## Access Compliance Report Public Rights-of-Way (Curb Ramps)

Intersection ID: 7699 Main Street: MT\_KISCO\_DR Cross Street: SQUIRREL\_HILL\_RD Location: NE

ADA ID: C9127C7121F7 Ramp Type: Perp Initial Pass/Fail: Fail Overall Compliance: No Severity Score: 12.5

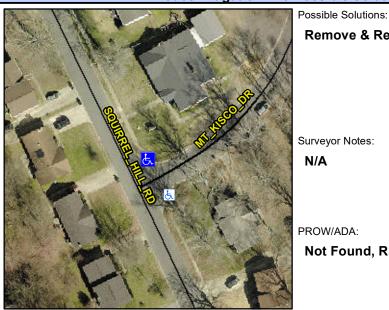
Field Measurements/Component Compliance					
Compliance Description		Data	Compliance Description		Data
N/A	Ramp Length (in)	47.5	No	Ramp Slope (%)	9.2
Yes	Ramp Width (in)	48.0	Yes	Ramp XSlope (%)	0.3
N/A	Flare Type LT	N/A	N/A	Flare Type RT	N/A
N/A	Flare Slope LT (%)	N/A	N/A	Flare Slope RT (%)	N/A
N/A	Flare Traversable LT?	N/A	N/A	Flare Traversable RT?	N/A
N/A	Landing Length (in)	N/A	N/A	DWS Provided?	N/A
N/A	Landing Width (in)	N/A	N/A	DWS Contrast?	N/A
N/A	Landing Slope (%)	N/A	N/A	DWS Length (in)	N/A
N/A	Landing X Slope (%)	N/A	N/A	DWS Full Width?	N/A
N/A	Landing Curb? (Y/N)	N/A	N/A	DWS Offset (in)	N/A
N/A	Shared Landing?	N/A			
N/A	Gutter Ponding?	N/A	N/A	Gutter Slope (%)	N/A
N/A	Gutter Lip Ht (in)	0.5	N/A	Gutter X Slope (%)	N/A
N/A	Painted X Walk1?	No	N/A	Painted X Walk2?	N/A
	X Walk 1 Direction	To SE		X Walk 2 Direction	N/A
N/A	X Walk 1 Width (in)	N/A	N/A	X Walk 2 Width (in)	N/A
	X Walk 1 Slope (%)	1.5		X Walk 2 Slope (%)	N/A

Total Cost: \$ 1850.00
